**Trans Mountain Pipeline ULC  
Trans Mountain Expansion Project  
NEB Hearing Order OH-001-2014  
Follow-Up Responses to Information Request from  
Adams Lake Indian Band**

**2.02.0 SURFACE WATER QUALITY ROUND 2 IRS**

**F-IR 2.02.5 Defensible analysis of the fate and behaviour of diluted bitumen releases and spill impacts in river**

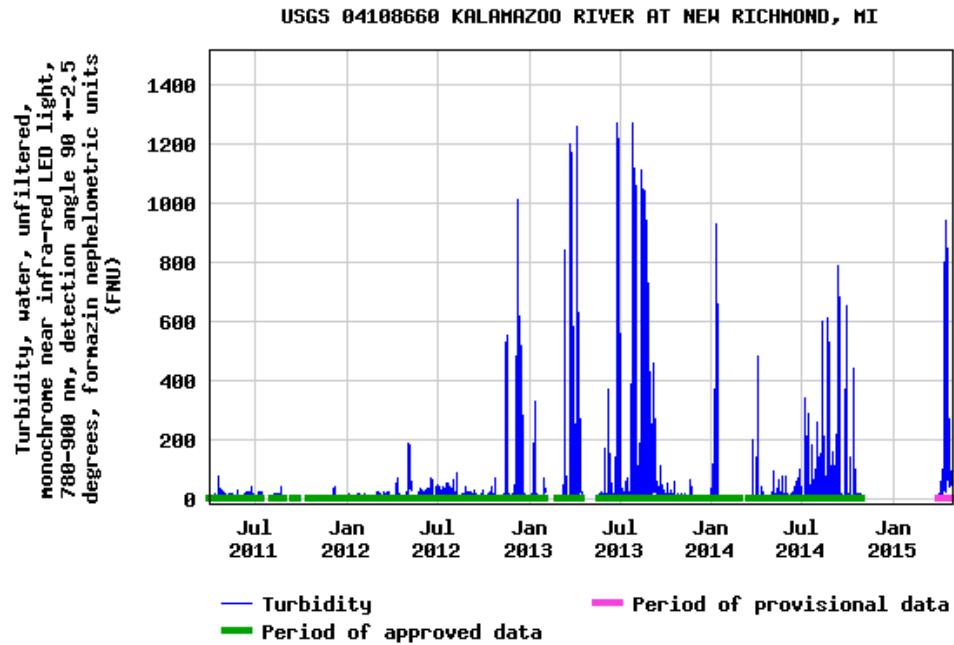
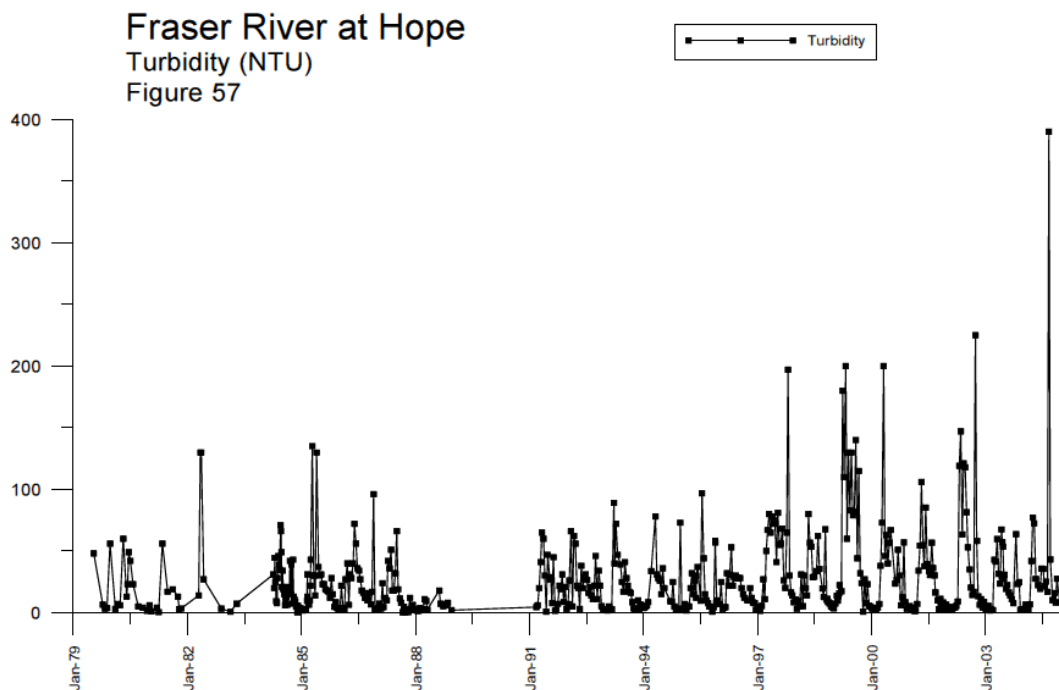
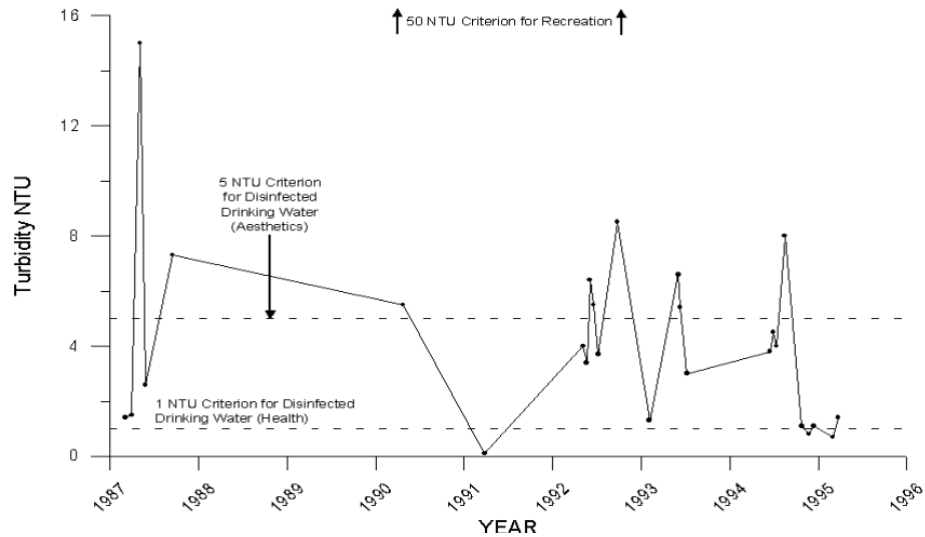
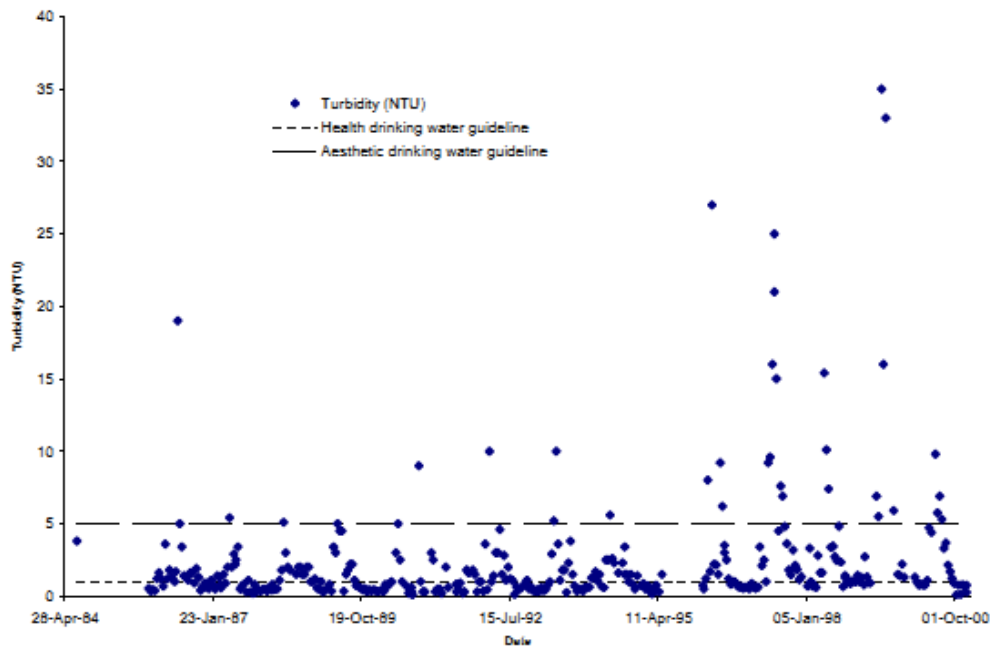
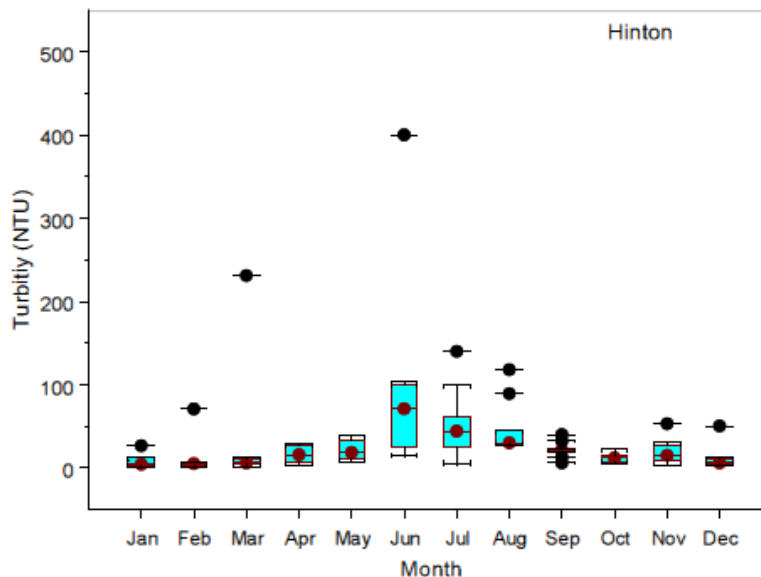
- d) The IR requested that TM formulate and use a quantitative relationship between the six parameters requested in ALIB IR 2.02.5 c (above) and OMA formation potential to calculate the probability of OMA formation in each hypothetical spill scenario. TM's response referred to a marine environment study on OMA formation (Payne et al. 1987) and calibration of an unnamed model. The response also refers to a "SPILLCALC" model that was not used in any of the hypothetical riverine spill scenarios. The response goes on to discuss suspended sediment concentrations along the marine transportation

route, as well as in the lower Fraser River. The response is very confusing, as it is unclear what model TM is referring to, why it is referring to a model that was not used in the riverine hypothetical spill scenarios or why it is discussing OMA formation in marine environments at all. It appears that TM believed that this IR, requesting information about the hypothetical riverine scenarios, was in fact requesting information about marine spills. This is important because water turbulence, temperature, suspended sediment concentrations and salinity in river systems are quite distinct from marine systems. The answer is therefore not relevant to the IR.

TM's response did refer to the Marshall spill, indicating that a non-negligible number of unknowns exists regarding sediment concentrations and overland travel. TM states that an attempt to extrapolate OMA formation would not be rigorous or defensible. It should be noted that overland travel of spilled diluted bitumen was included in the spill scenarios for the Athabasca River, North Thompson River and Fraser River (Trans Mountain 2013). No mention of the Athabasca River, the North Thompson River or the Fraser River conditions was made, except as mentioned above. No reference to parameter estimates from OMA formation studies was made. No mention of the six parameters was made, apart from suspended sediment. As requested in the original IR, TM should provide the quantitative relationships for all six parameters and OMA formation potential at the three hypothetical spill locations. If TM is not able to complete such a formulation, or believes that insufficient data exists to complete such a formulation, it should state this.

One can see that turbidity data at New Richmond, MI, for the Kalamazoo River reaches 1,200 NTU during freshet. In comparison, the Fraser River at Hope reaches about 400 NTU during the freshet, the North Thompson River reaches 16 NTU and the Athabasca River reaches 400 NTU. Hence, a factor of 3 to 75 separates turbidity levels between the Kalamazoo (the highest) and the other rivers.

As described in Table F-IR 2.02.5d-1 of this IR, a non-negligible number of unknowns exist regarding the environmental parameters during the Marshall spill, such as the absence of quantification of mineral sediment and organic debris pickup during the overland portion of the spill. Furthermore, as shown in Table F-IR 2.02.5d-1, the turbidity conditions in the Kalamazoo River during flow conditions similar to those which occurred during the spill, are significantly different, *i.e.* much higher, than the Fraser, North Thompson and Athabasca rivers. Based on this information only, the potential for OMA or other oil aggregates formation was much greater in the Kalamazoo River.

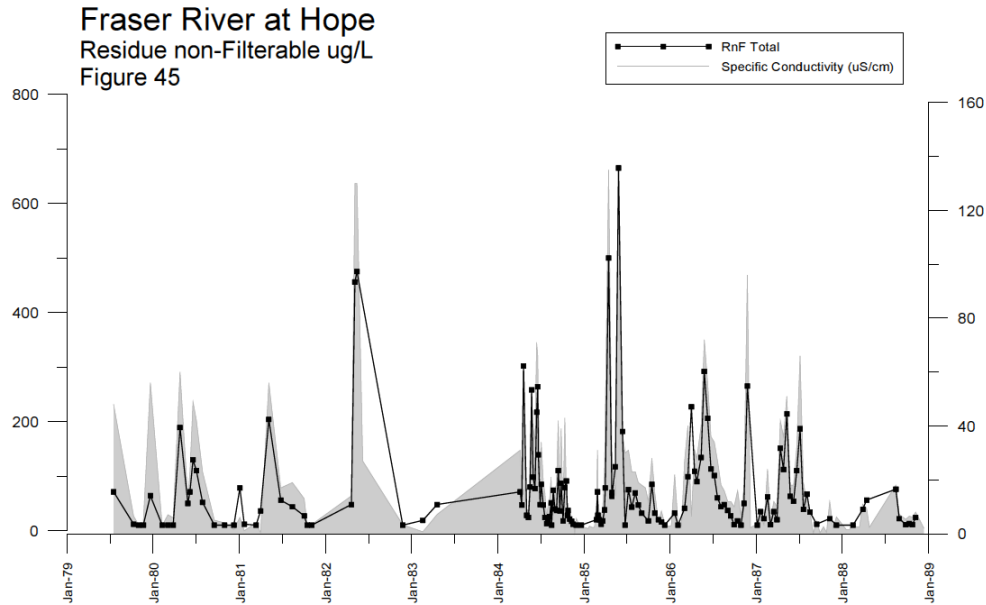
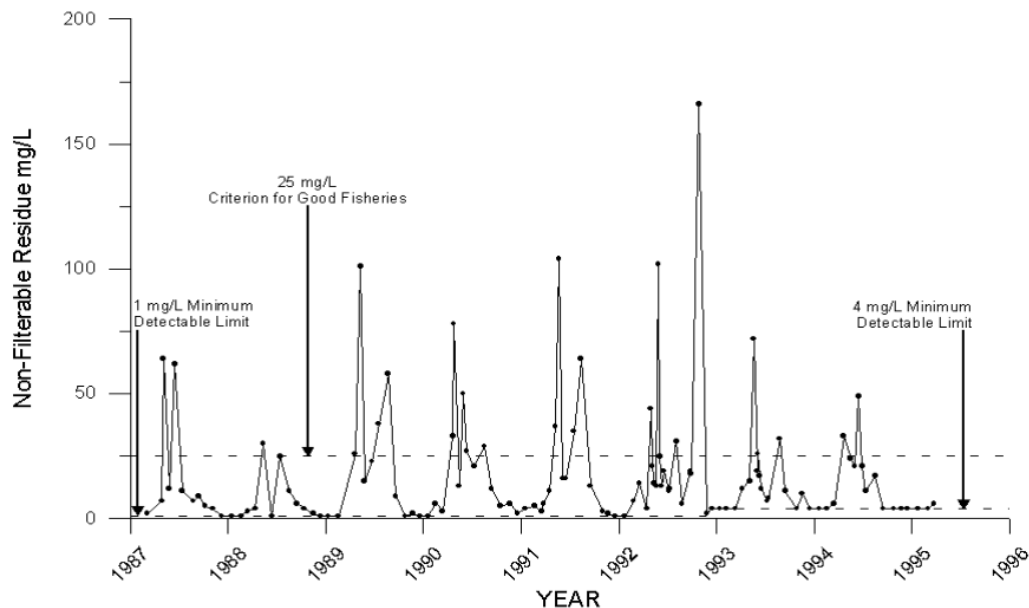
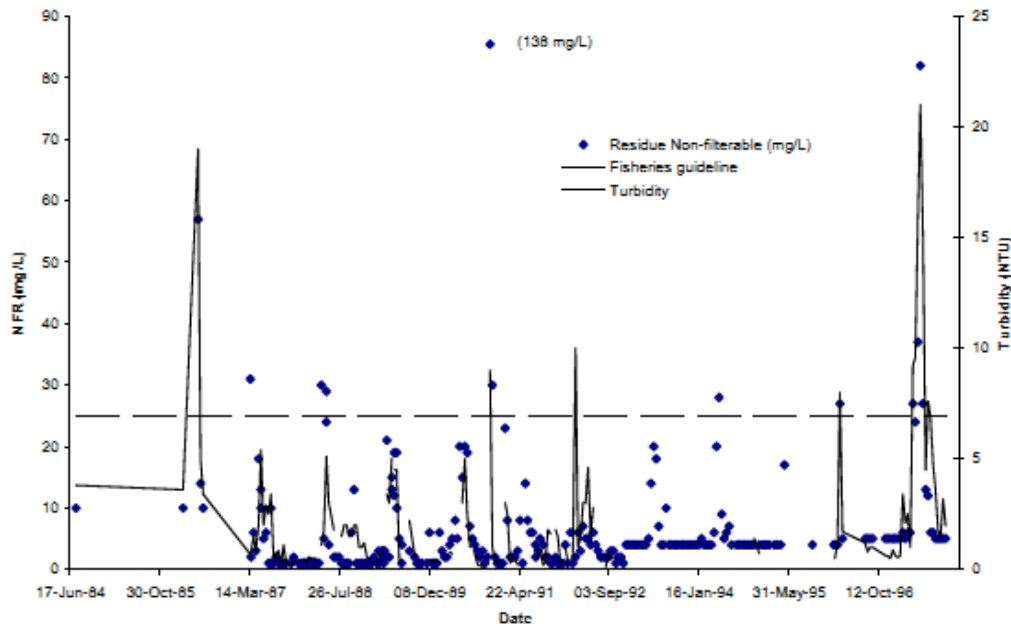
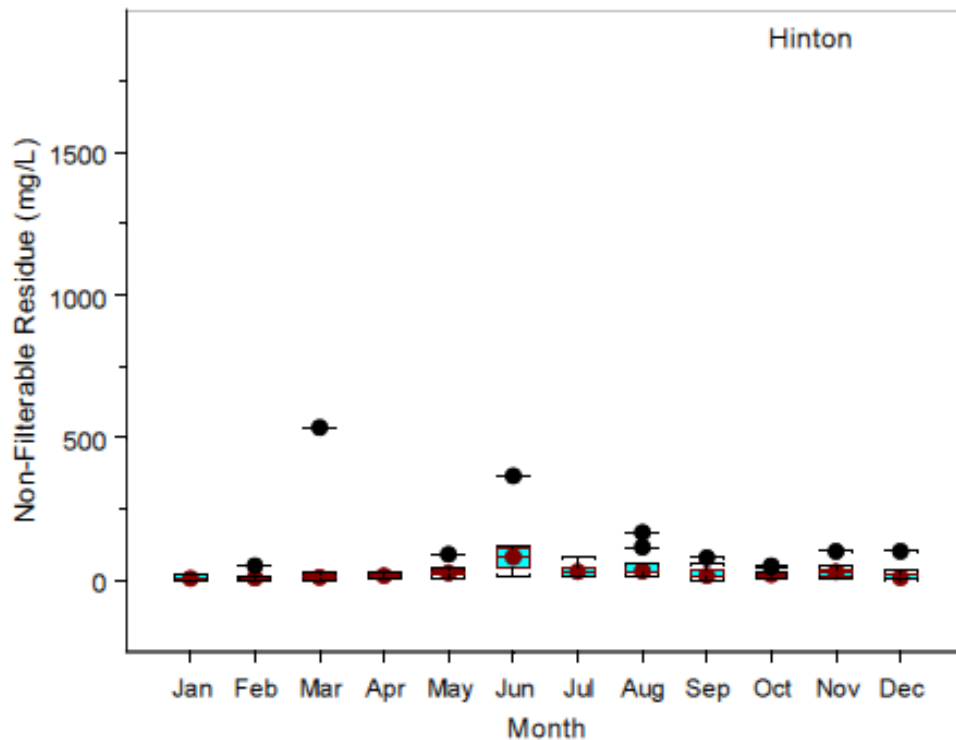
- e) This IR requested that TM ensure that data, conditions and outcomes of the Environment Canada (EC) study on diluted bitumen behaviour in water is included in the comparison of OMA formation potential. TM's response stated that the high sediment concentration considered in the EC study effectively make it not useful for such a comparison of OMA formation potential. Specifically, TM states that EC uses an upper bound sediment concentration of 10,000 mg/L, but does not provide a reference for this statement. We were unable to find such a figure in the EC report, and the response is incomplete. In addition, TM's response includes a comparison of this 10,000 mg/L figure with sediment concentrations in the Fraser River and at several marine sites. As with the response to ALIB IR 2.02.5 d (above), TM appears to believe that this IR was requesting information about marine spills, instead of riverine spills. **TM should provide a specific section and page number reference for the 10,000 mg/L figure that it cites. TM should also compare the sediment concentrations used in the EC report with those found at the Athabasca River, North Thompson River and Fraser River hypothetical spill sites.**

- e) Table F-IR 2.02.5e-1 shows a comparison of sediment concentrations used in the Environment Canada study and found in the rivers. The Environment Canada Report considered extremely high sediment concentration to provide an upper bound on the potential OMA formation. They used a sediment concentration of 10 g/L or 10,000 mg/L, which is orders of magnitude above typical and maximum values found on the West Coast. This value is clearly described in p.45 of Environment Canada's report: "The sediment loading chosen was 10 g sediment/L brine. While high, this level of suspended sediment has been found in coastal river outflows". On page 51 of Environment Canada's report, the use of 10 g/L is repeated. These pages of the Environment Canada's report have been presented in Attachment 1 (ALIB F-IR IR No. 2.02.5e-Attachment 1).

As Environment Canada conducted their experiment with sediment concentration values that are one to two orders of magnitude greater than what is observed in the Fraser, North Thompson and Athabasca Rivers, data and conditions used by Environment Canada could not be used. They are not representative of river conditions in the West Coast; rather they provide an upper bound on the potential OMA formation.
